# TOWN OF WAITSFIELD

## INVITATION TO BID BIG EDDY COVERED BRIDGE GAP REPAIRS ADDENDUM #1

Sketch by architect Bob Burley of west end gap repair alternative recessing the barrier so to not cover the historic covered bridge post details. This would require some form of stable flooring or base to fill the downward gap such that it would not give way when anyone (child or adult) steps on it.

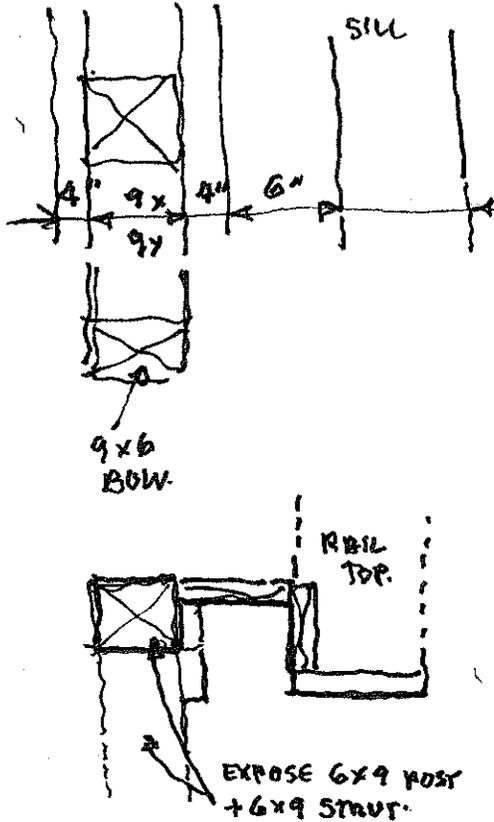
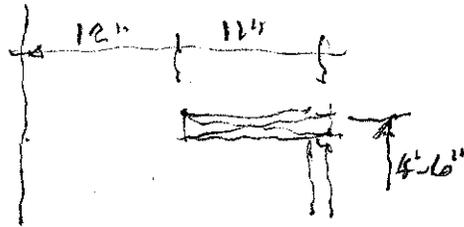
- The existing siding is eastern white pine, common premium grade.
- Architect Bob Burley proposed an alternative configuration for sealing the gaps at the end. See attached sketch. The Town supports this alternative. It will require a horizontal component at the bottom to obstruct the gap.
- The historic bridge moves as vehicles pass through; the pedestrian bridge does not, so the new wall work must remain separated from the existing pedestrian bridge components.
- Electricity is expected to be available at the site.
- Attached are sheets 7 and 10 from the construction plans with dimensional details.
